<b>APPLICATION NUMBER</b>	<b>HW/WD/16/1677/MAJ</b>
---------------------------	--------------------------

**Location:** ROCKINGTON NURSERY, BLACKNESS ROAD, CROWBOROUGH, TN6 2NB

**Development:** 34 NO. DWELLINGS INCLUDING PROVISION FOR ACCESS ONTO BLACKNESS ROAD.

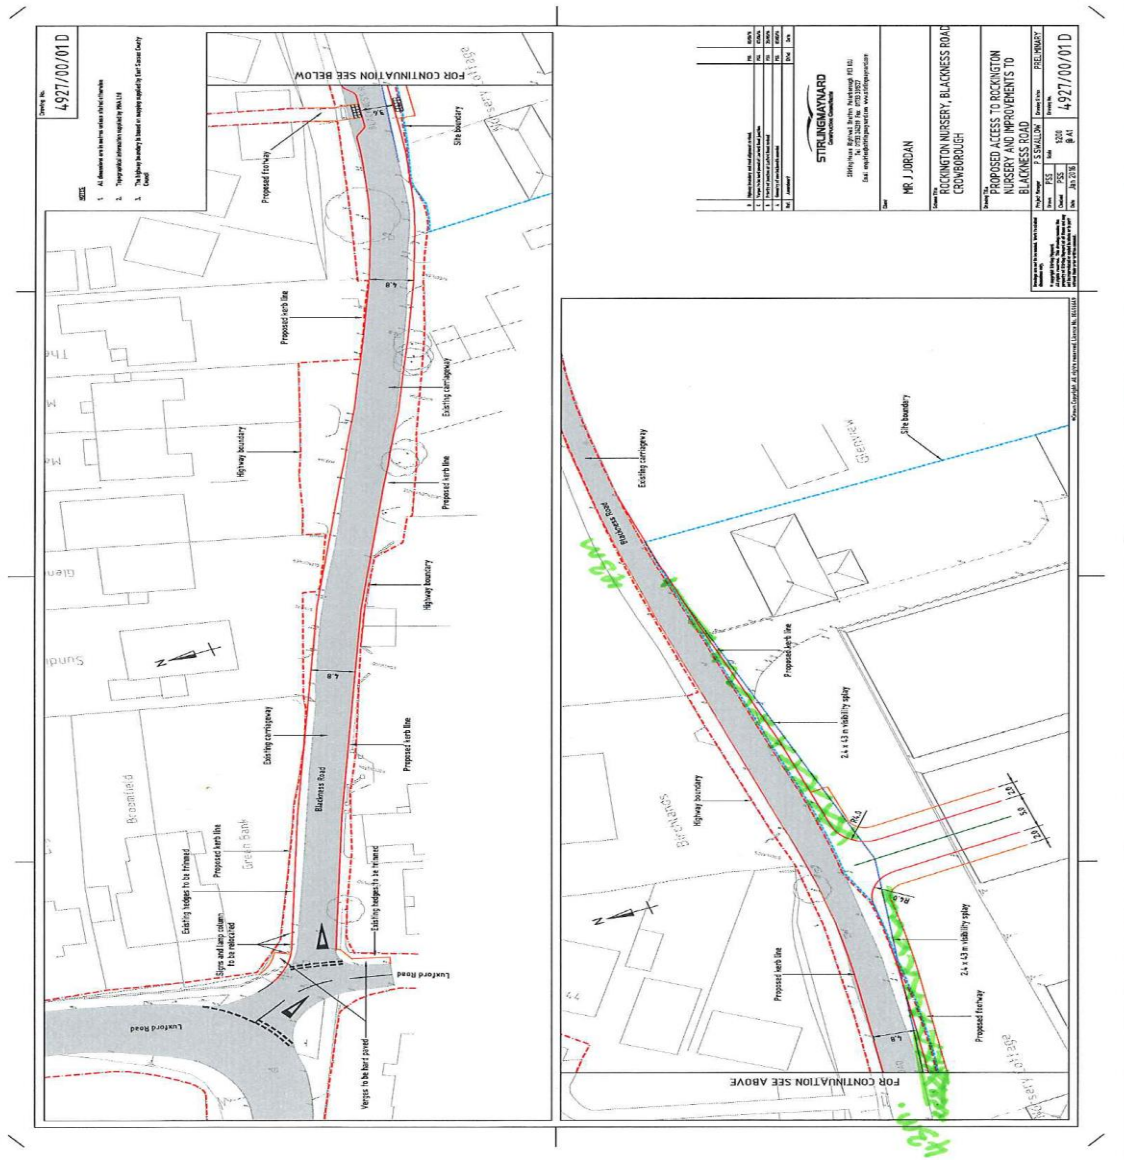
4m radii recommended.
